**RE: BREMO POWER STATION VPDES PERMIT NO. VA0004138:
REVISED CONCEPT ENGINEERING REPORT FOR THE WEST TREATMENT POND**

CONCEPT ENGINEERING REPORT: WEST TREATMENT POND

Bremo Power Station

June 2016
Revised August 2016 (Rev. 1)

BREMO POWER STATION
STATION WATER FLOW
POST CONSTRUCTION (FINAL)
ONE LINE DIAGRAM

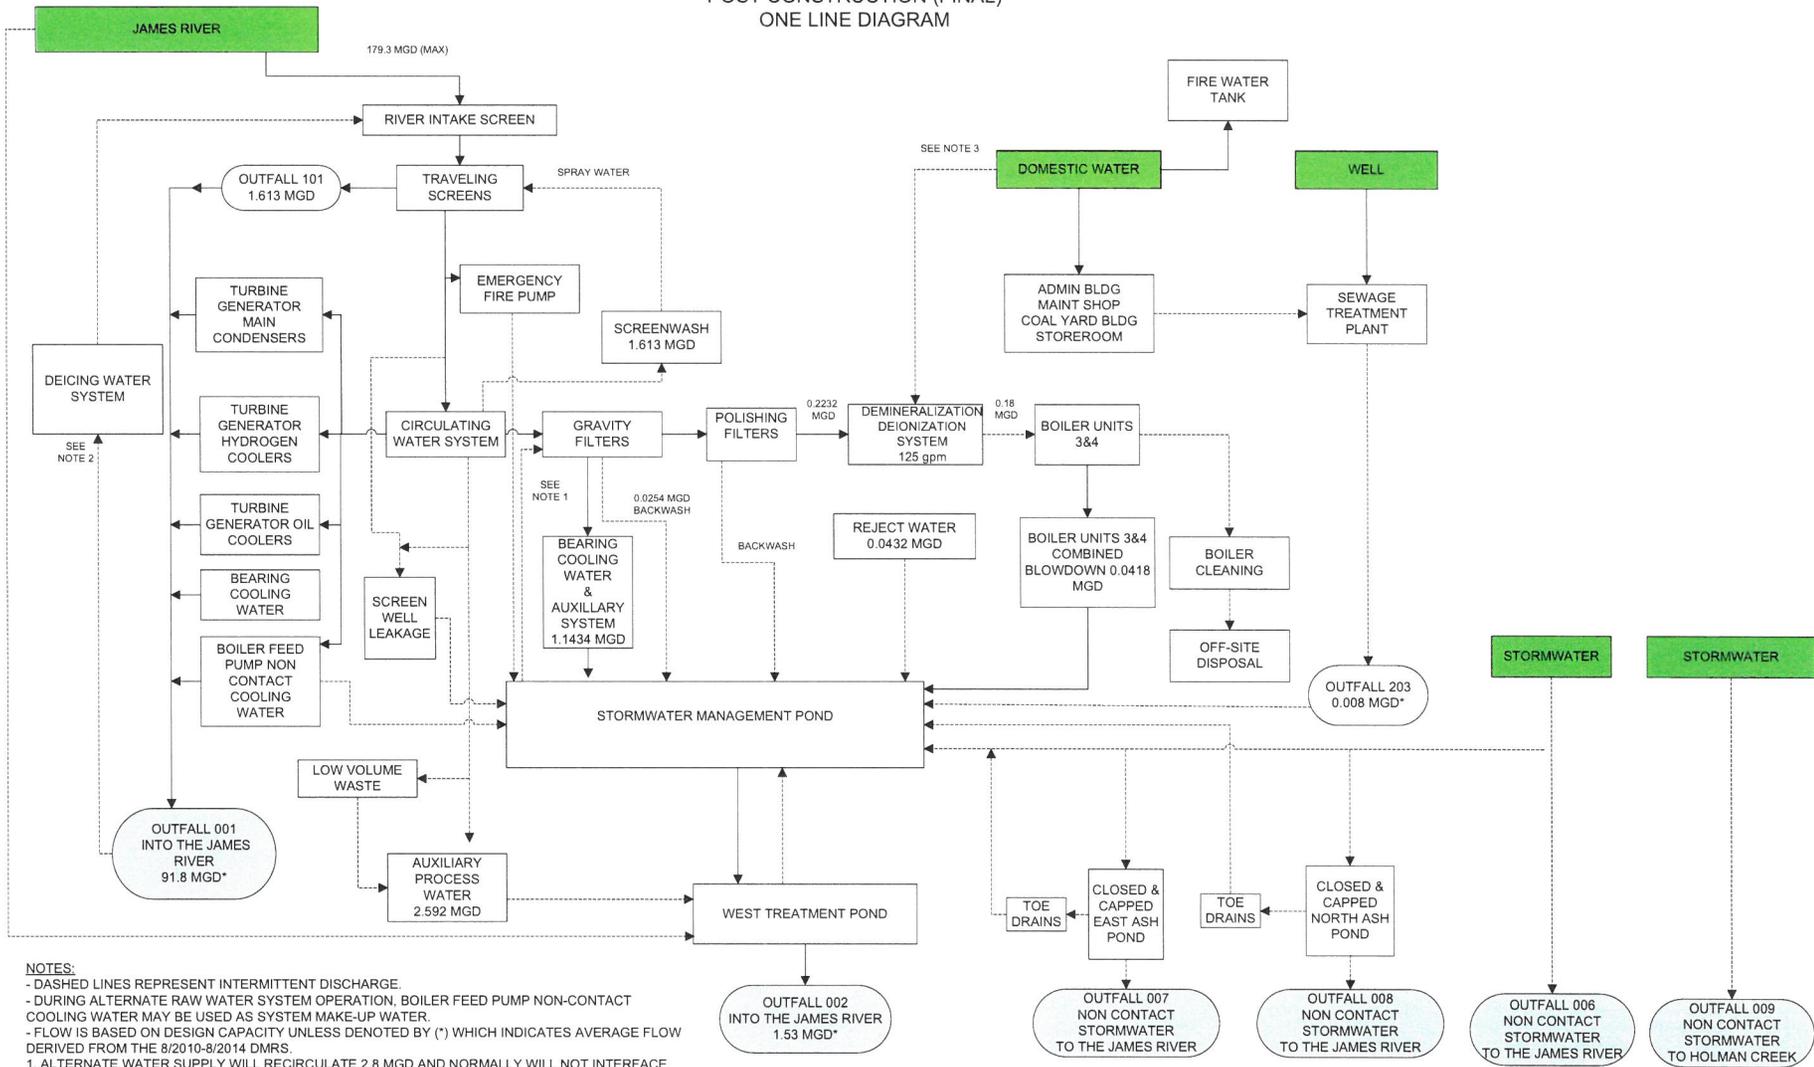
2. Revised Drawing 4 (Process Flow Diagram of Final Conditions) to remove outfall 204 from the Stormwater Management Pond, changed "Stormwater Treatment Pond" to "Stormwater Management Pond," and inserted the current date

7. Section 2.1.7 – changed "Stormwater Treatment Pond" to "Stormwater Management Pond"
8. Section 2.1.7 – added that water can be routed back to the Stormwater Management Pond from the West Treatment Pond if needed to facilitate maintenance of the West Treatment Pond, or to provide process make-up water, consistent with Drawing 4
